**Amendments to the Drawings:**

The attached sheet of drawings includes changes to Figs. 1A-1D. This sheet, which includes Figs. 1A-1D, replaces the original sheet including Figs. 1A-1D.

FIG. 1A

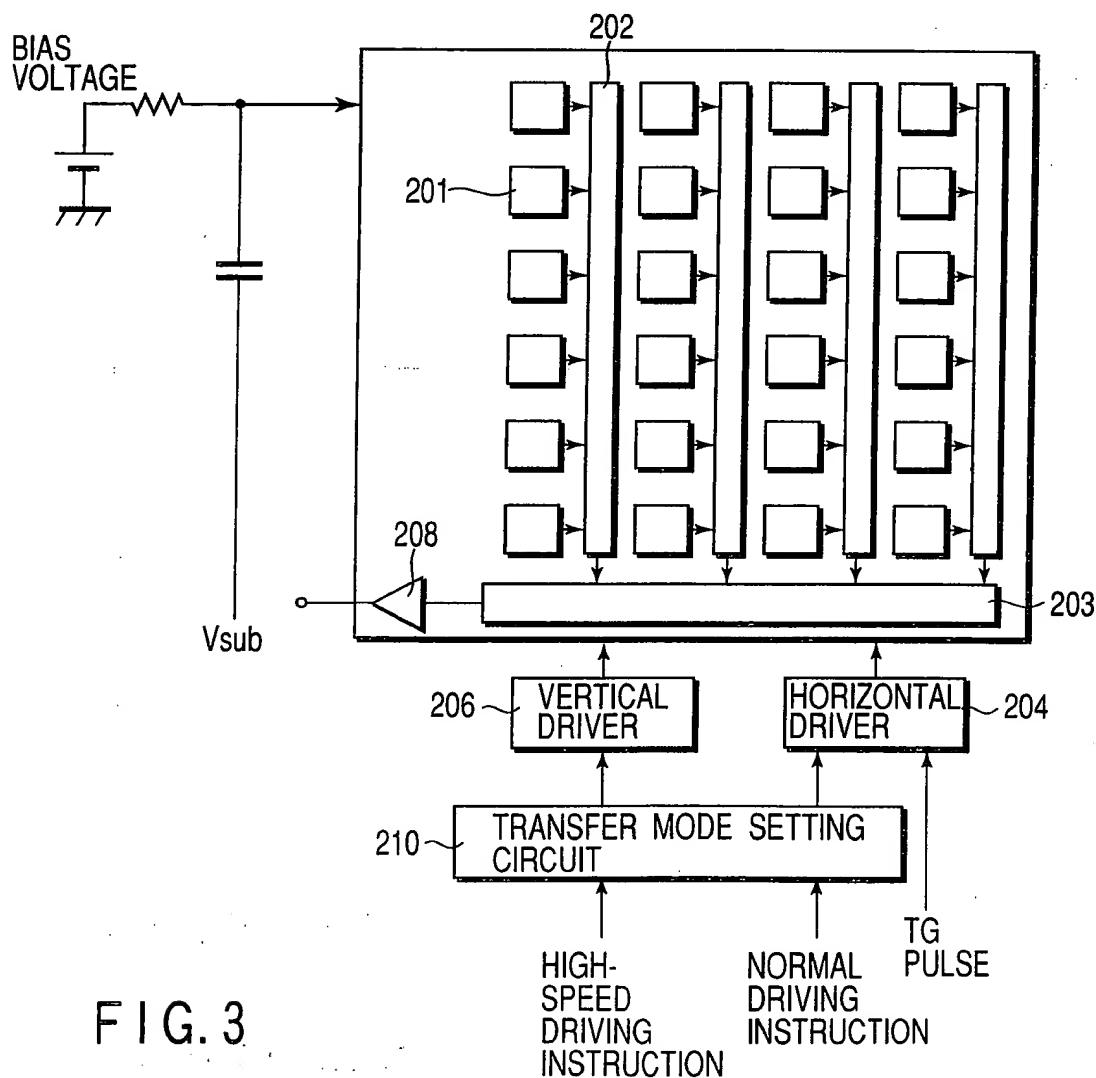
(Prior Art)

(Prior Art)
